From: tony buckman <tonybuckman@hotmail.co.uk>
Sent: 09 November 2016 12:33
To: Meachen, Tracey
Subject: Re: 30 Westlode Street, Spalding

Looking at the condition compliance application reference H16-1039-16, **condition 9** does not need formal discharge. The condition states timber construction. This would improve the appearance of the development and would be more acceptable within the Conservation Area. There are points where the building would be seen.

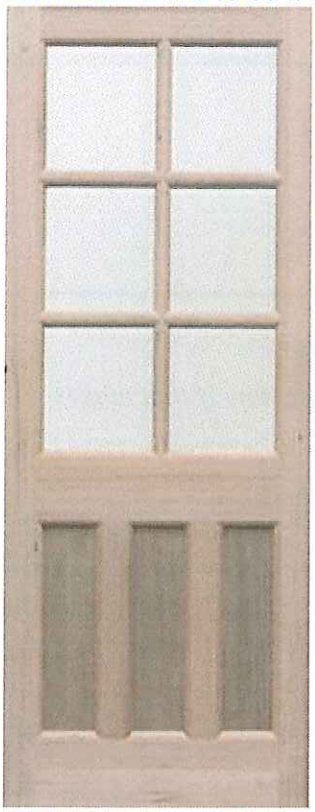
2. For this application, would you please confirm that the proposed window style would be Jeld-Wen cottage bar? You did say on the brochure style as per quote sheet style, but no quote sheet was included. The image you supplied later appears to be cottage bar pge 224.

1. I believe the client(Peter) is going to contact you regarding the assessment for heritage.
2.Yes the image below is for a timber horizontal bar as per the drawings and the casement window within the brochure.
